JAMES A. FITZPATRICK NUCLEAR POWER PLANT

AMENDMENT TO FACILITY OPERATING LICENSE

Amendment No. 49
License No. DPR-59

ATTACHMENT TO LICENSE AMENDMENT NO. 49

FIGURE 3.5-7 MAXIMUM AVERAGE PLANAR LINEAR HEAT GENERATION RATE (MAPLHGR) VERSUS PLANAR AVERAGE EXPOSURE

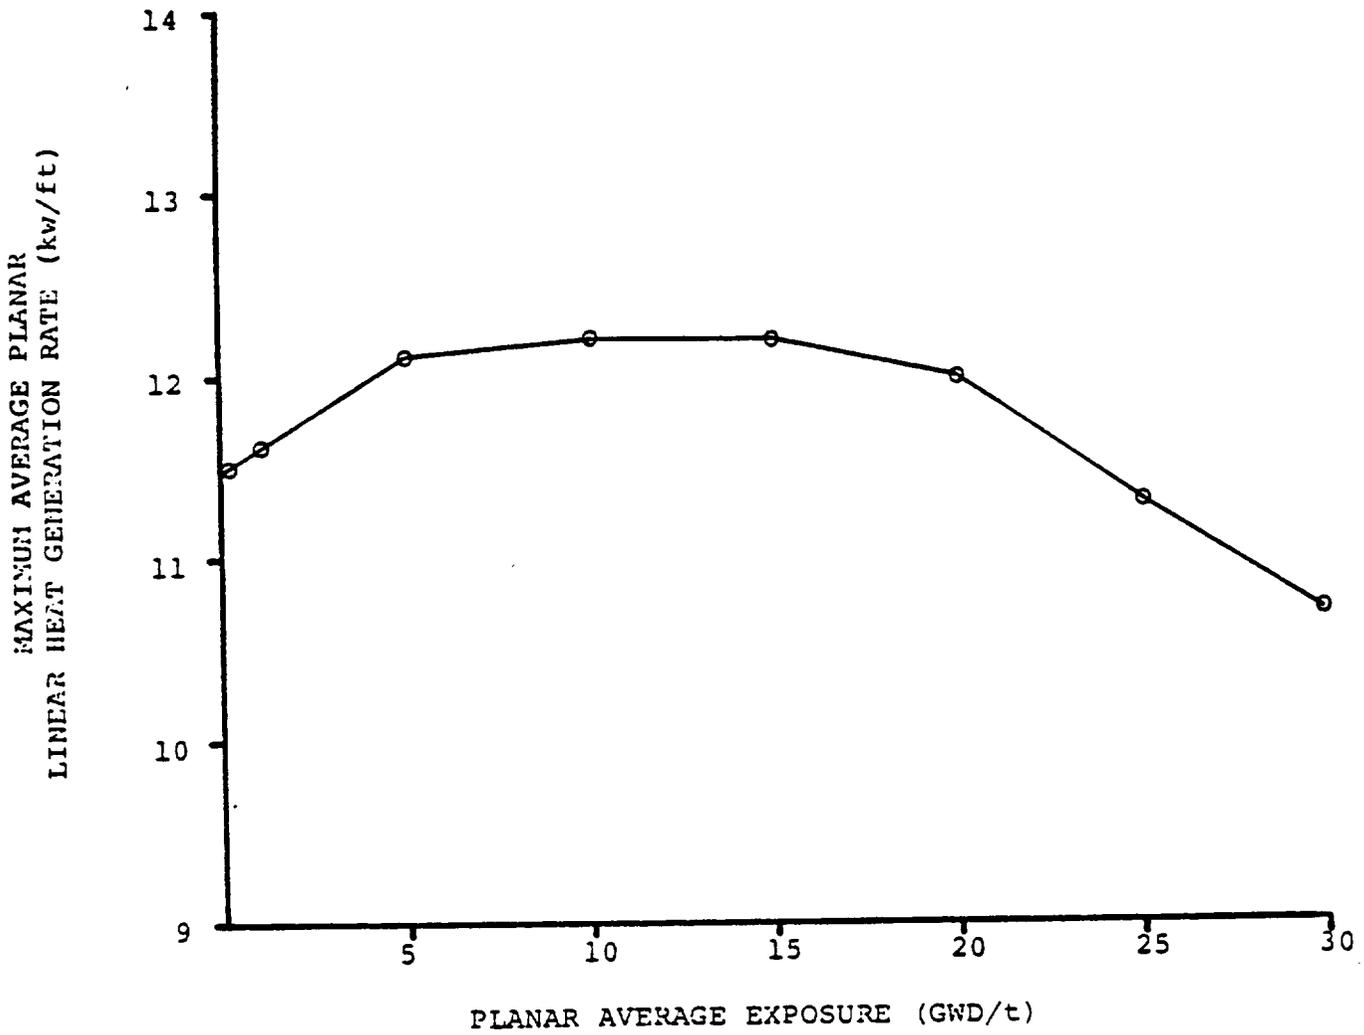
The APLHGR for each type of fuel as a function of average planar exposure shall not exceed the limiting value shown in Figures 3.5.1 through 3.5.8. If anytime during reactor power operation greater than 25% of rated power it is determined that the limiting value for APLHGR is being exceeded, action shall then be initiated within 15 minutes to restore operation to within the prescribed limits. If the APLHGR is not returned to within the prescribed limits within two (2) hours, an orderly reactor power reduction shall be commenced immediately. The reactor power shall be reduced to less than 25% of rated power within the next four hours, or until the APLHGR is returned to within the prescribed limits.
